METROPOLITAN GOVERNMENT OF NASHVILLE AND DAVIDSON COUNTY

STAFF RECOMMENDATION 2517 Blair Boulevard January 20, 2021

Application: New Construction—Addition; Setback Determination
District: Hillsboro-West End Neighborhood Conservation Zoning Overlay
Council District: 18
Base Zoning: RS7.5
Map and Parcel Number: 10415002700
Applicant: Blaine Bonadies, Architect
Project Lead: Sean Alexander, sean.alexander@nashville.gov

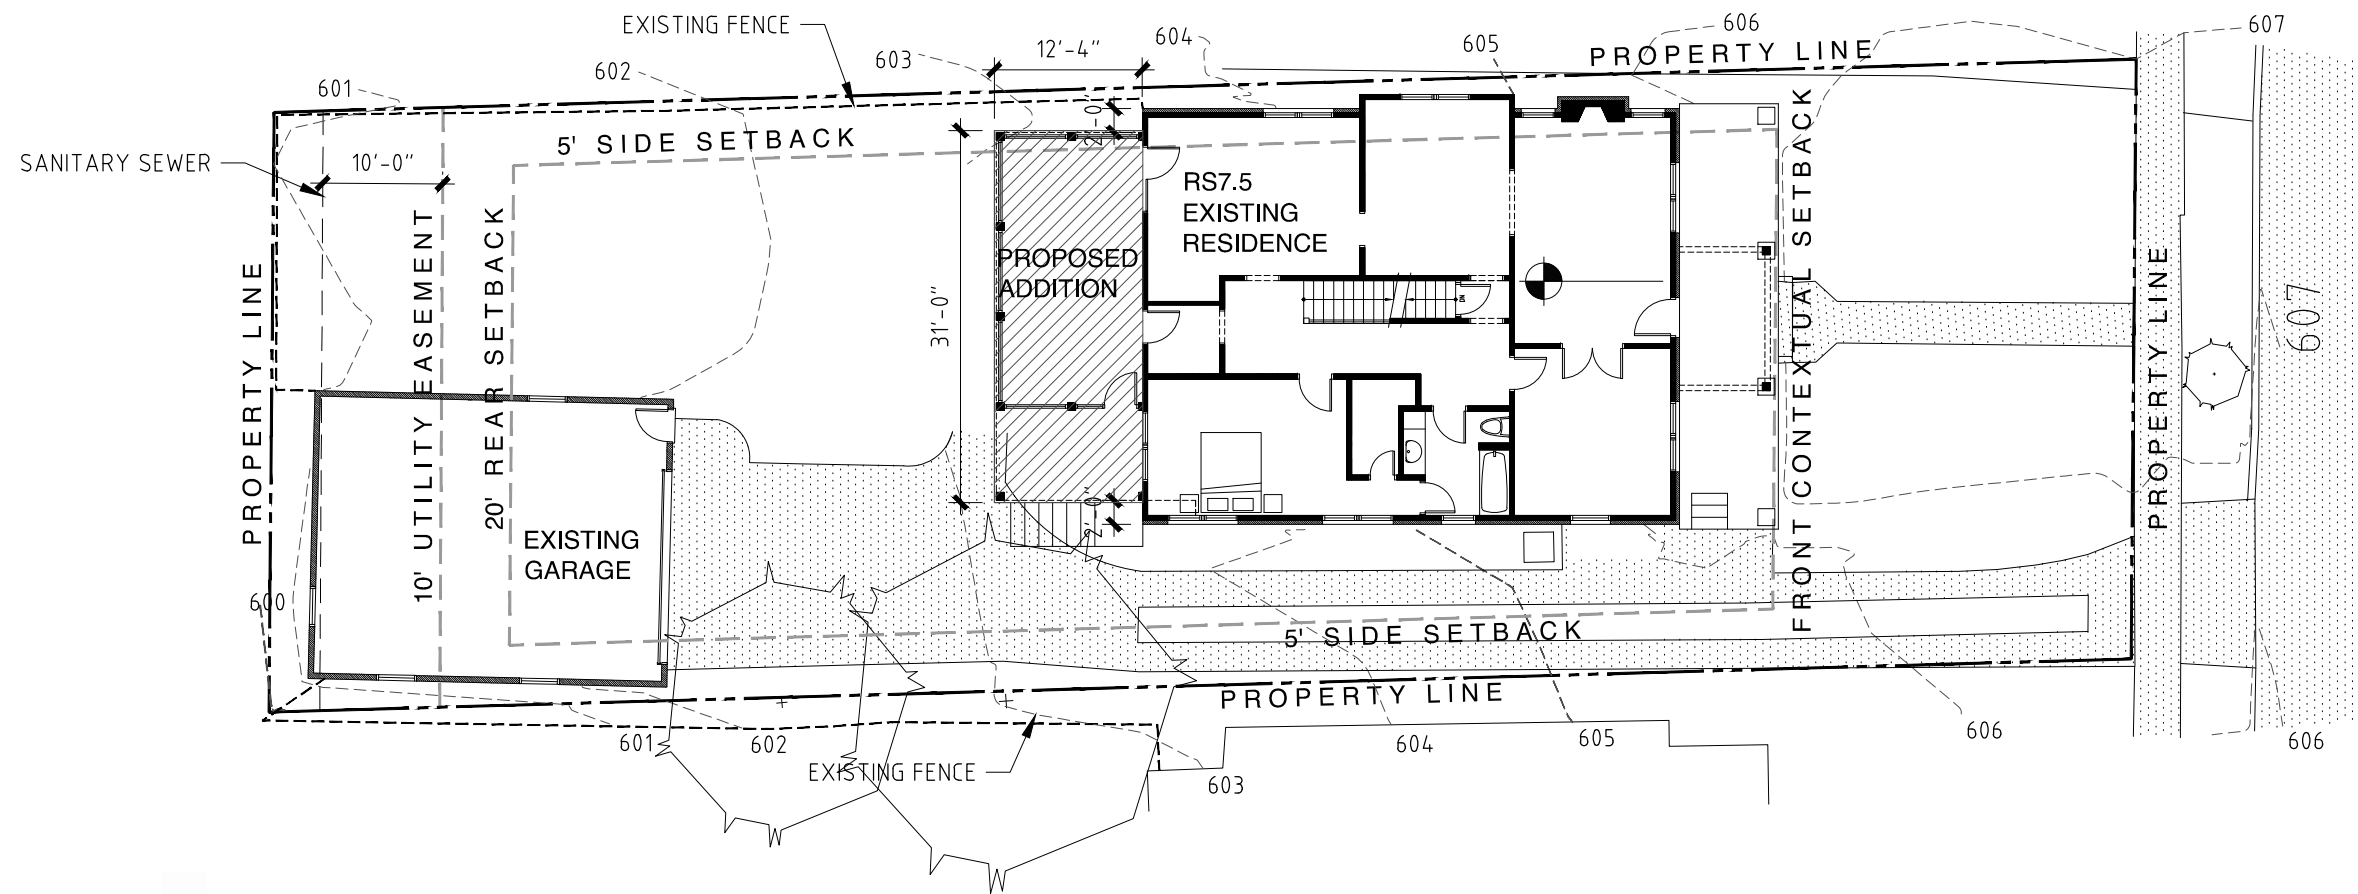
Roof form: The roof of the addition will comprise a side-oriented gable with clipped ends, matching the pitch and form of the historic house's roof. The original and new side-oriented gables will be connected by a cross-gable ridge. The rear slope of the addition's roof will have a shed-roofed dormer, stepped in ten feet (10') from the left side and eight feet (8') from the right. The dormer will stack directly over the rear wall of the addition. While dormers are typically required to step in from the first story walls on the side, they are not required to step in from the rear because the rear cannot be seen from the right-of-way.

Staff finds that the roofs of the proposed infill are compatible with the roof of the historic house and meet section II.B.1.e. of the design guidelines.

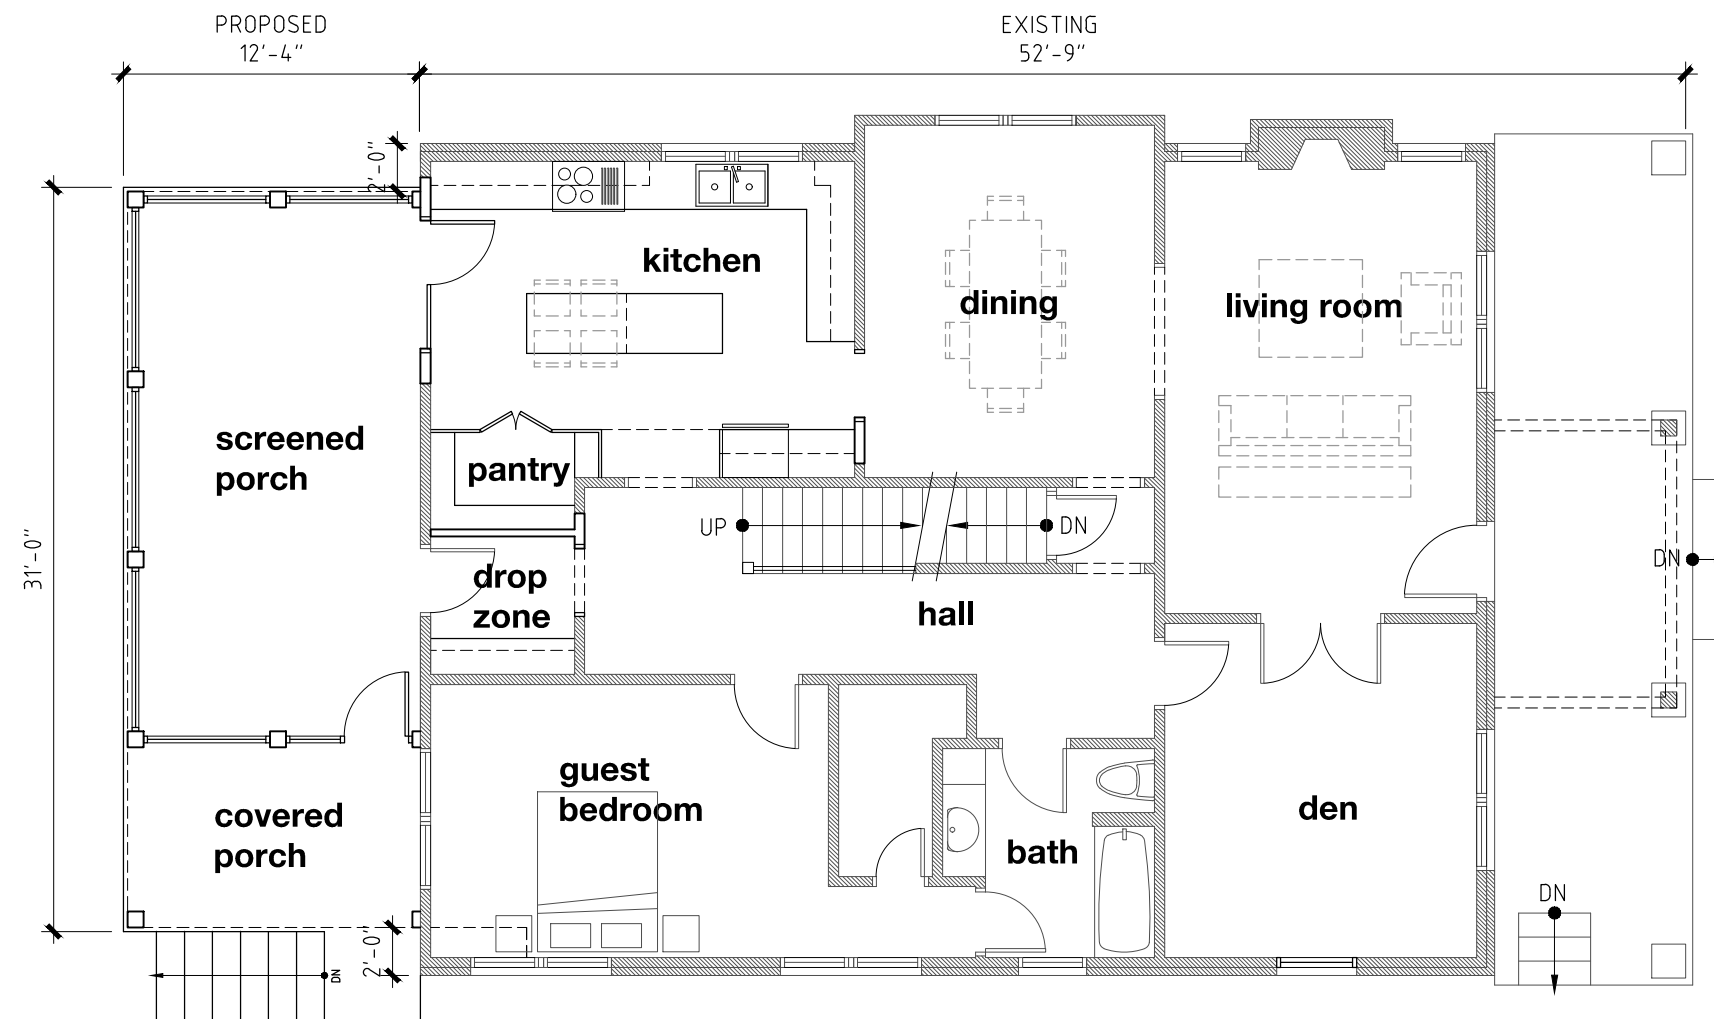
Proportion and Rhythm of Openings: The windows on the sides of the proposed addition will be consistent with the pattern and proportions of windows on the historic house.

Staff finds the project's proportion and rhythm of openings is compatible with the historic house, meeting Section II.B.1.g. of the design guidelines.

first floor plan

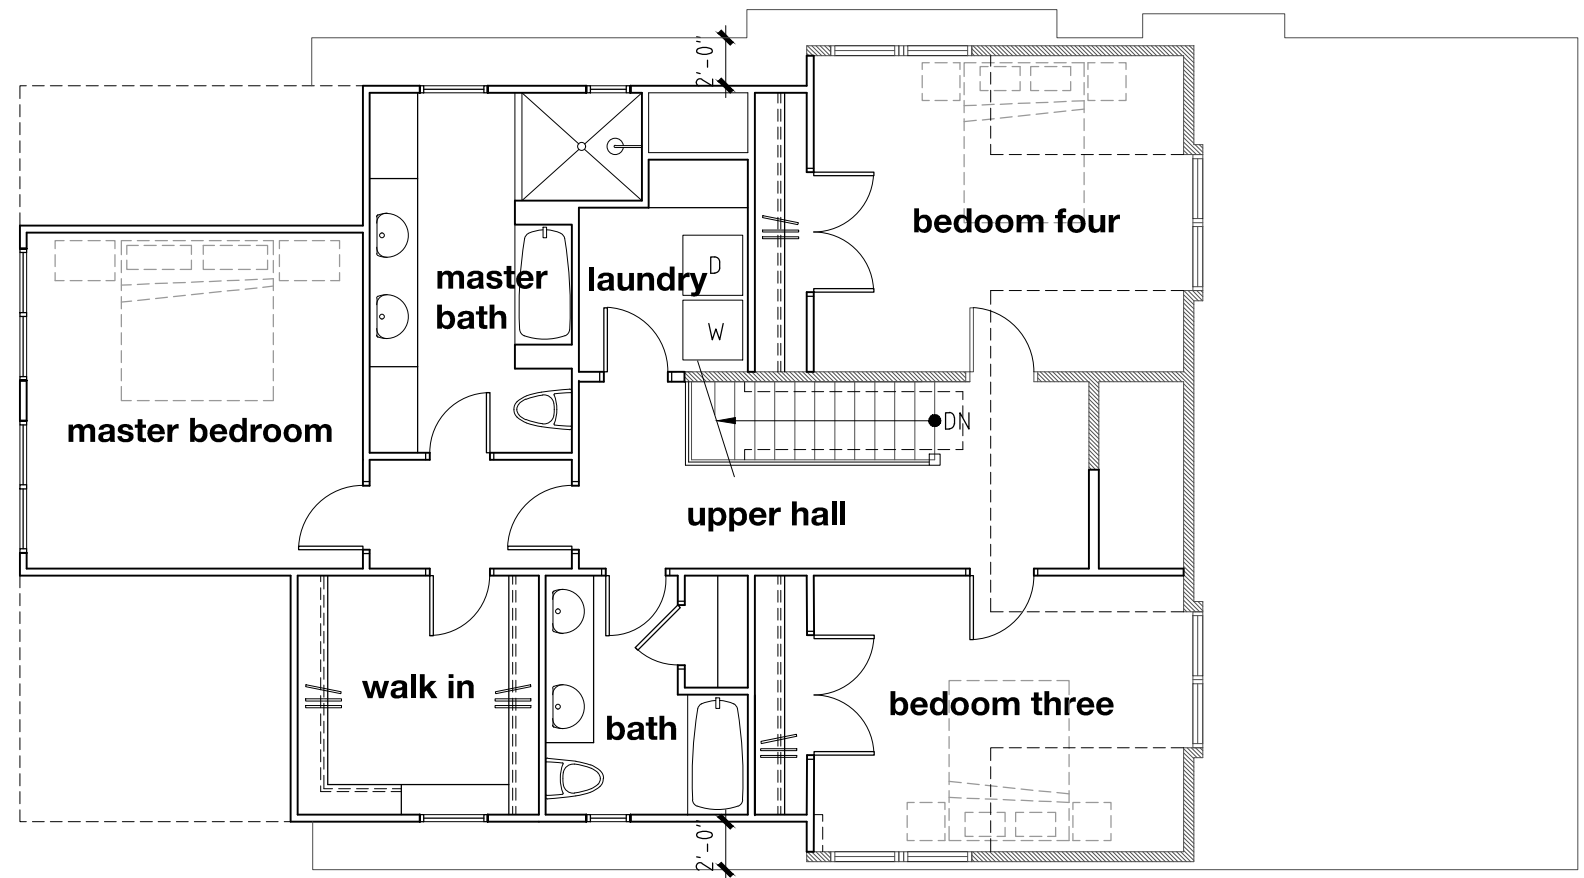
Location & Removability: The addition will attach to the historic house at the rear, stepping in two feet (2') from the side walls on both sides before continuing to the rear. The addition's change in materials, inset, and separate roof form help to distinguish it from the historic house and read as an addition to the house. At the same time, its scale, materials, and roof form are all compatible with the historic character of the existing house. Much of the addition is designed so that if the addition were to be removed in the future, the historic character of the house would still be intact.

Height & Scale: The proposed addition will tie into the ridge of the existing house and extend back without going taller. The addition will be stepped in two feet (2') from the sides of the historic house on both sides, extending the footprint twelve feet (12') to the rear.

Setback & Rhythm of Spacing: The orientation of the house is slightly askew from the axis of the property lines, and the rear-right corner of the historic house sits approximately two feet (2') from the right-side property line. Although the addition is stepped in two feet (2') from the right side of the house, the rear-right corner of the addition will be approximately three feet (3') from the property line. Staff finds this setback to be appropriate because of the location and orientation of the historic house. The left side of the addition, which is also stepped in two feet (2') from the side of the historic house, will be more than fifteen feet (15') from the left side property line.
